HBR2
CYCLE 10 RELOAD

TECHNICAL SPECIFICATION
CHANGES

CORE PROTECTION BOUNDARIES FOR 3-LOOP OPERATION
 Figure 2.1-1

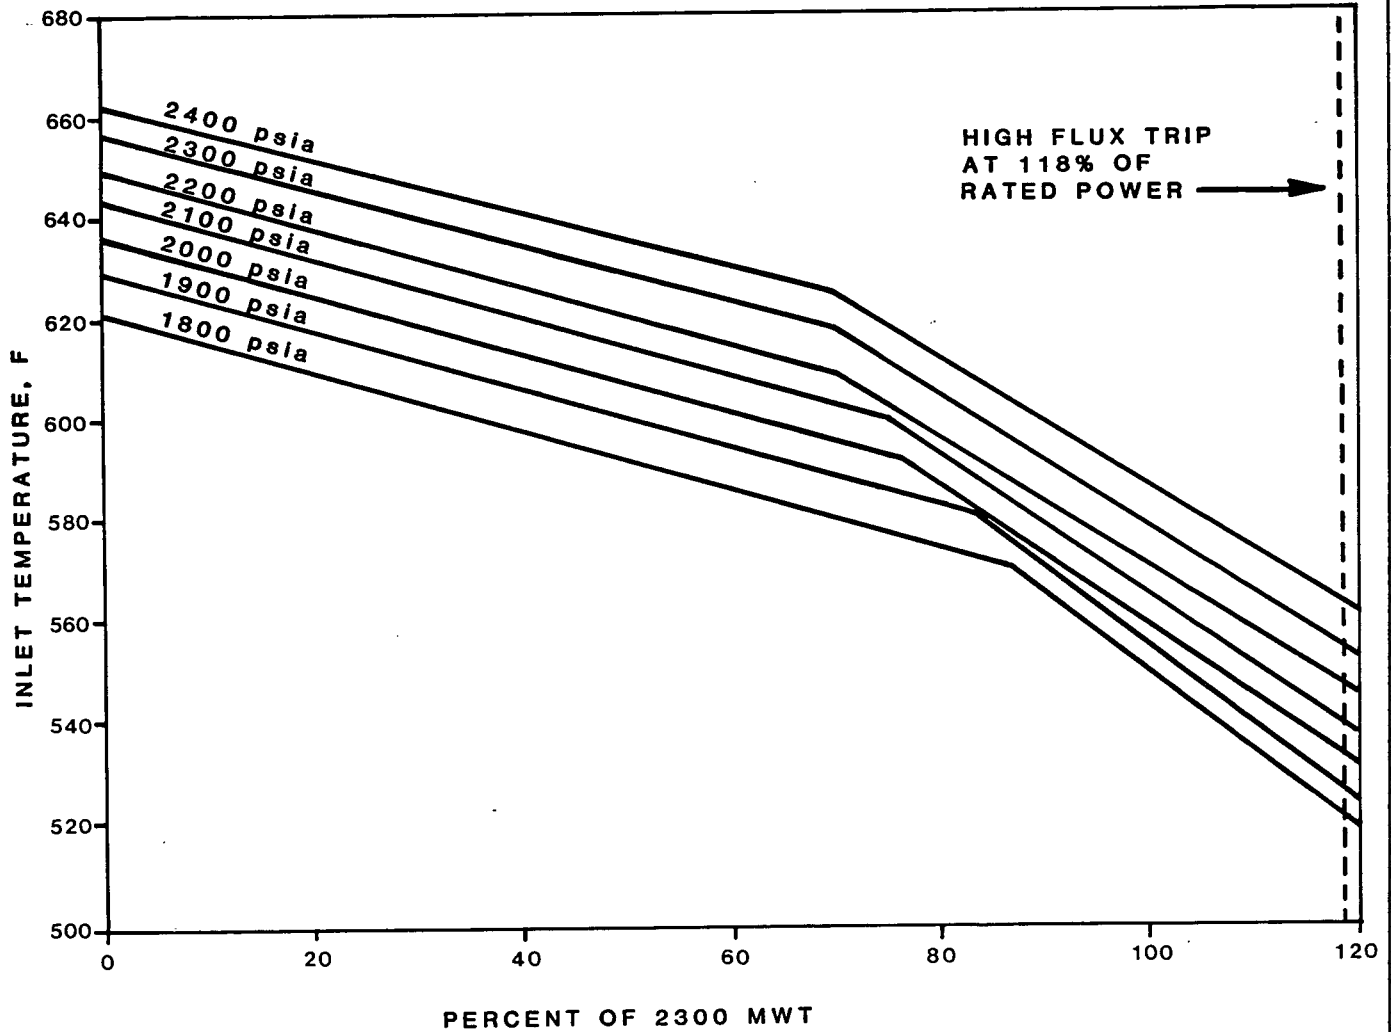
- a. The combination of thermal power level, coolant pressure, and coolant temperature shall not exceed the limits shown in Figure 2.1-1 when full flow from three reactor coolant pumps exists.

- d. The safety limit is exceeded if the combination of Reactor Coolant System average temperature and thermal power level is at any time above the appropriate pressure line in Figure 2.1-1 or if the thermal power level, coolant pressure, or Reactor Coolant System average temperature violates the limits specified above.

Additional peaking factors to account for local peaking due to fuel rod axial gaps and reduction in fuel pellet stack length have been included in the calculations of the curves shown in Figure 2.1-1. The figure also includes the effects of uprating to 2300 MWt.⁽³⁾

Figure 3.10-3

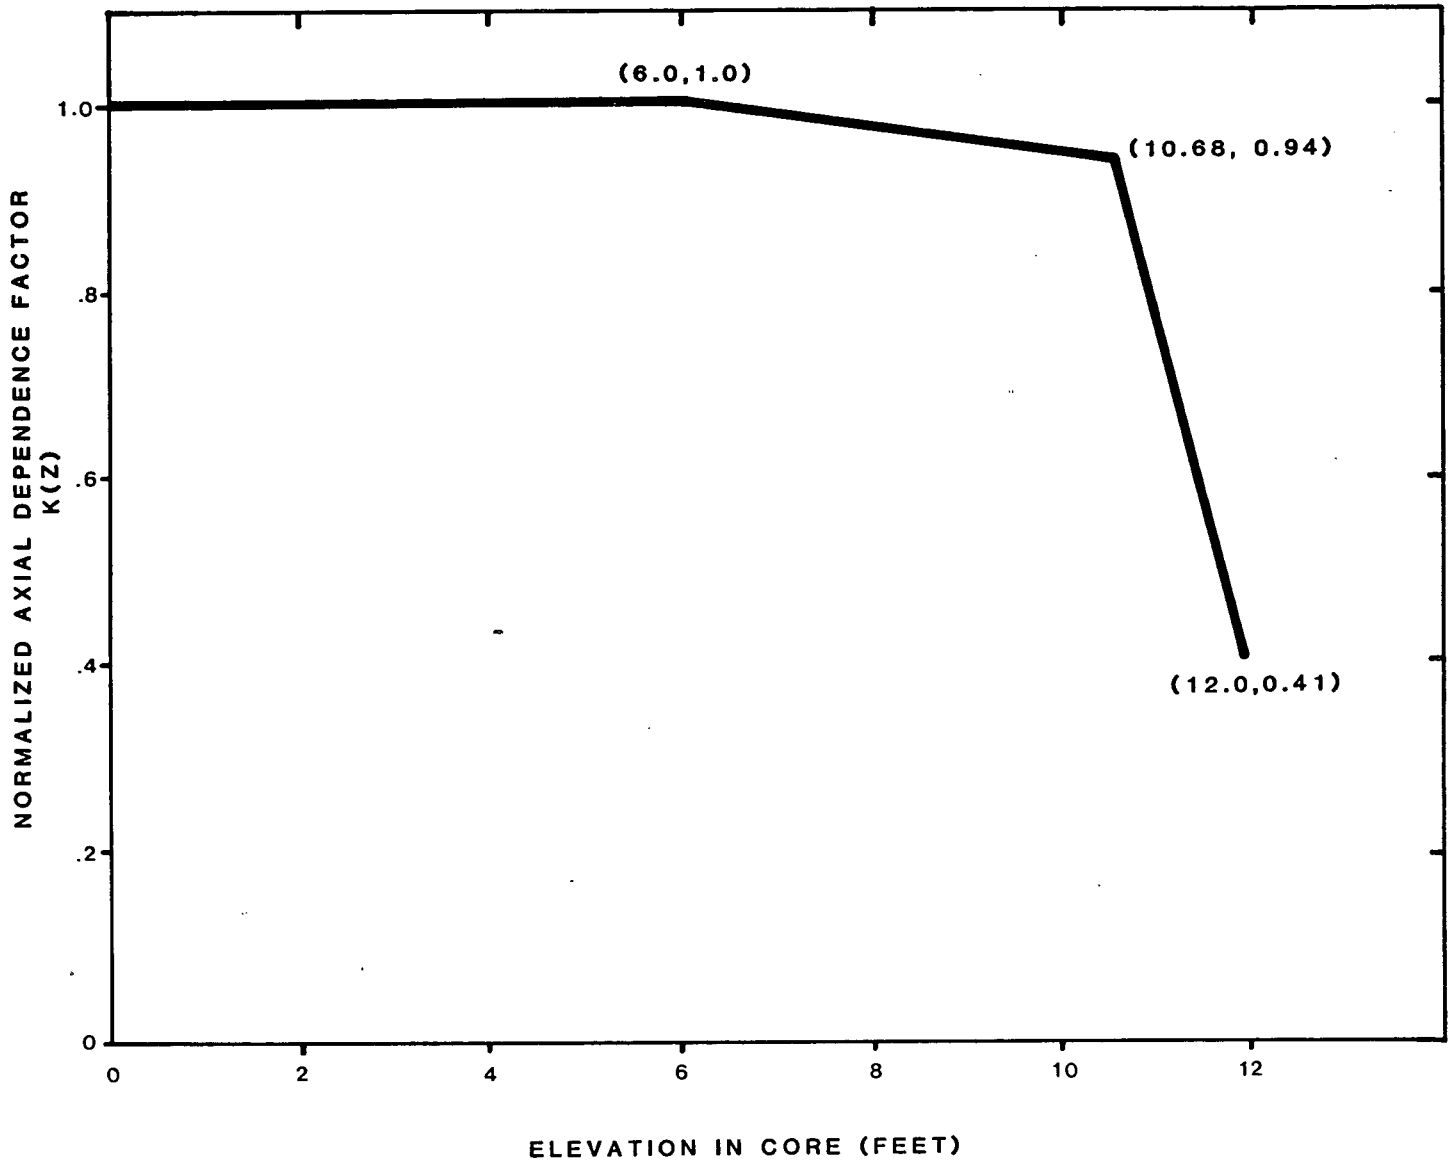
$F_{\Delta H}$ is the measured $F_{\Delta H}$ including a 1.04 measurement uncertainty factor. $K(Z)$ is based on the function given in Figure 3.10-3, and Z is the axial location of F_Q .

Figure 3.10-4

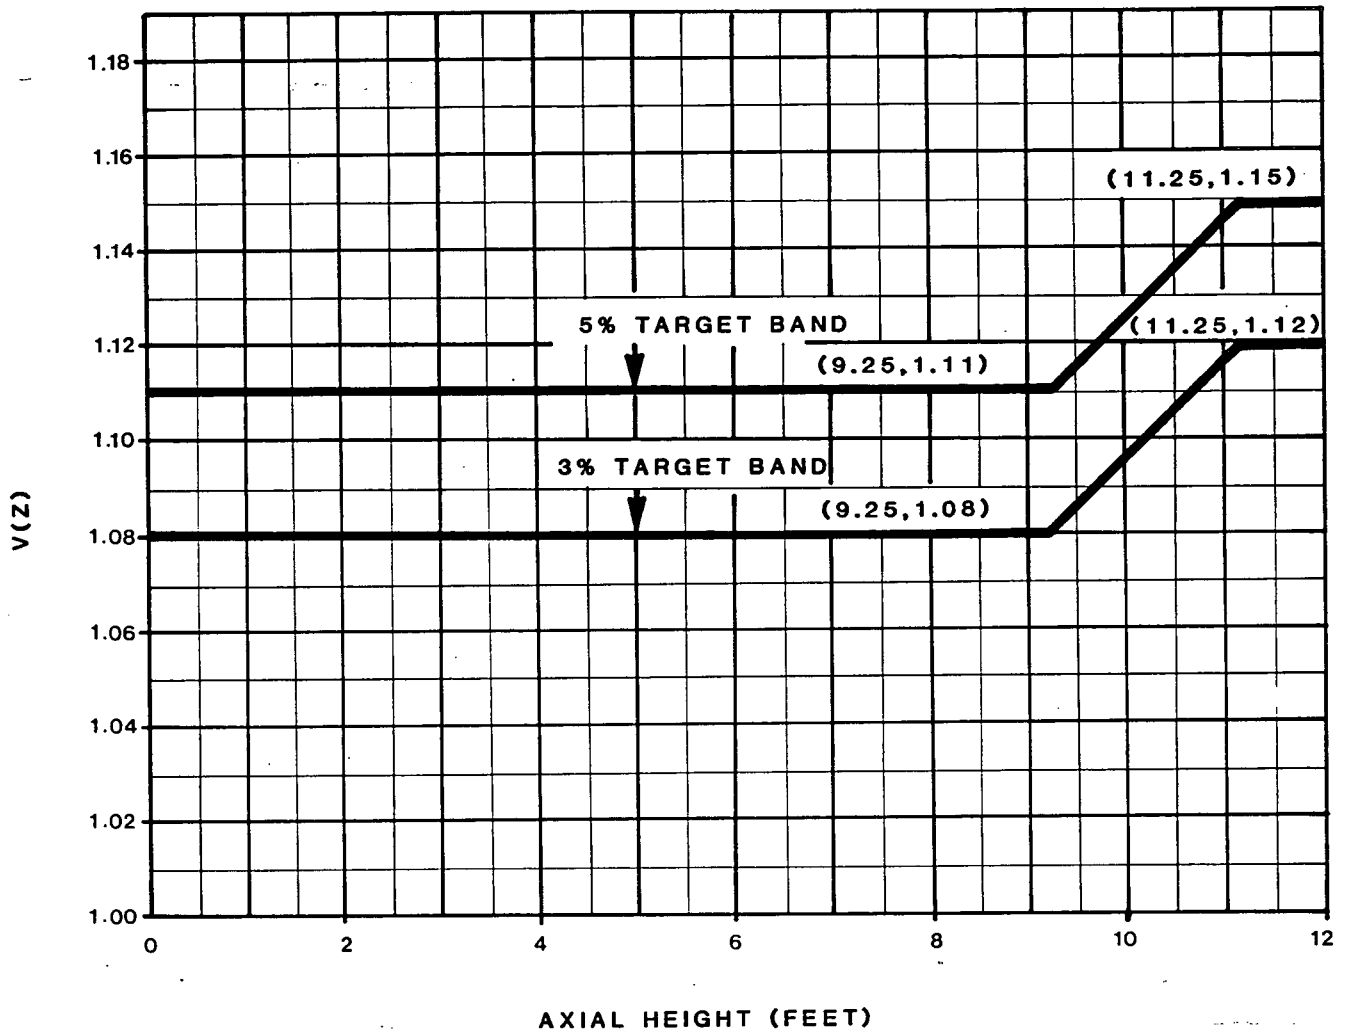
where $V(Z)$ is defined in Figure 3.10-4 which corresponds to the target band and $P > 0.5$.

Figure 3.10-5

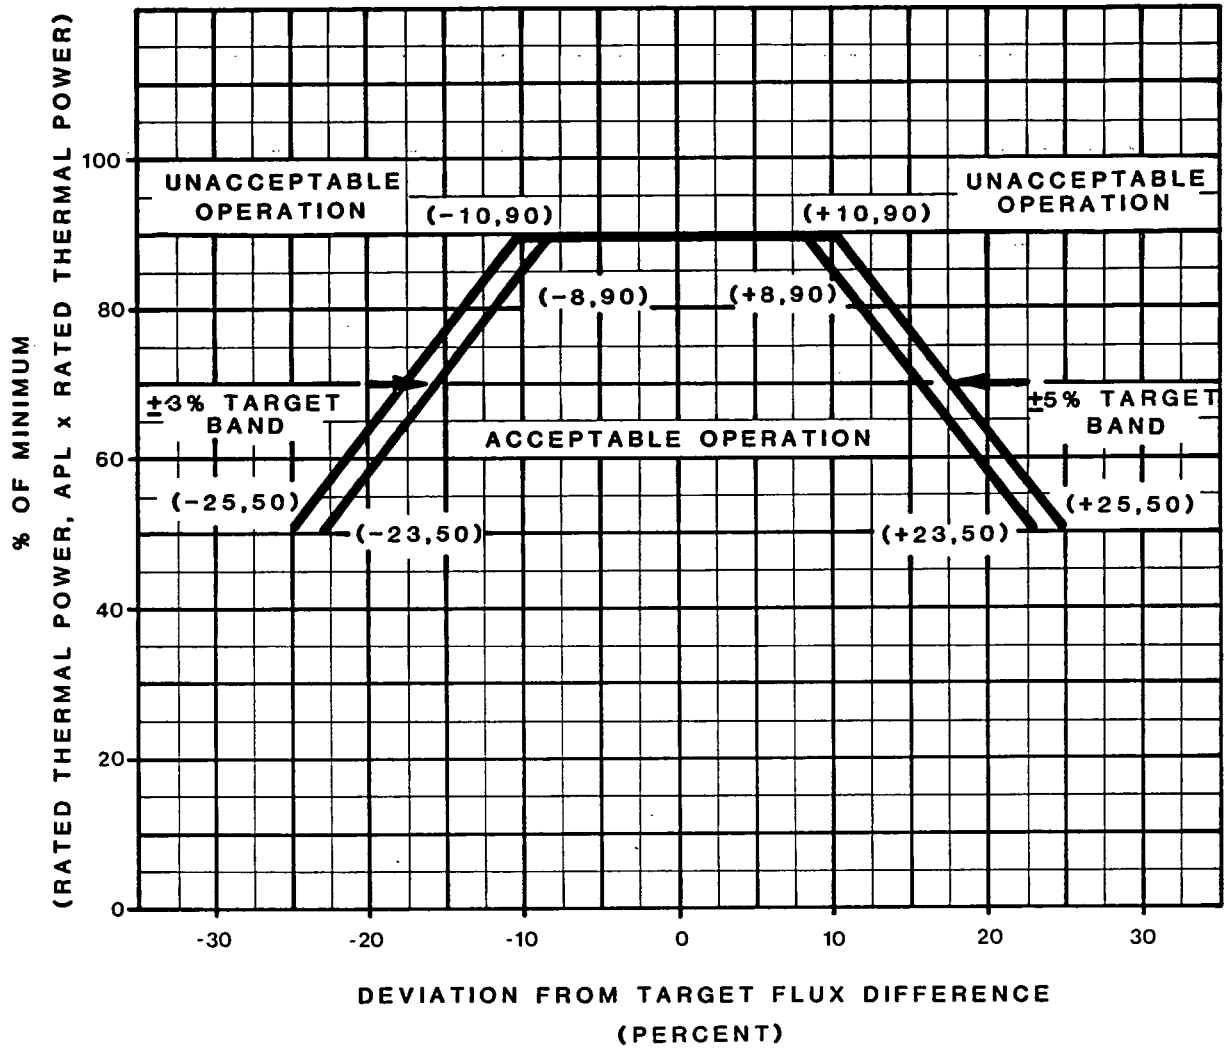
- a. The indicated axial flux difference may deviate from its target band for a maximum of one hour (cumulative) in any 24-hour period provided the flux difference does not exceed the limits shown in Figure 3.10-5. If the cumulative time exceeds one hour, then the reactor power shall be reduced immediately to no greater than 50 percent of rated power and the high neutron flux setpoint reduced to no greater than 55 percent of rated power.
- b. A power increase to a level greater than 90 percent or $0.9 \times \text{APL}$ (whichever is less) of rated power is contingent upon the indicated axial flux difference being within its target band.

3.10.2.9 Calibration of the excore detectors will be performed at a power level no greater than 90% or $0.9 \times \text{APL}$ (whichever is less) of rated power. The indicated axial flux difference may deviate from its target band during the calibration provided the flux difference does not exceed the limits shown in Figure 3.10-5.
